AM04 / 2022

## Conversion of brake shoes for 10 - 12 t low loader trailer axles

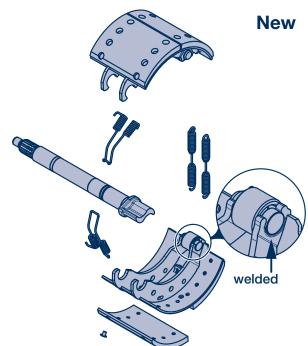
Brake shoe 05.091.14.77.1 is being replaced by brake shoe 05.005.79.34.1 as part of a product optimisation process for 10 - 12 t low loader trailer axles with brake SN 3020.

As part of this optimisation, the brake roller bolt will now be welded to the brake shoe bridging plate to increase strength for axle loads ≥ 10 t.

Brake shoe: 05.091.14.77.1 (still valid for 9 t axles with SN 3020)

Brake shoe: 05.005.79.34.1 Repair kit: 09.801.09.35.0
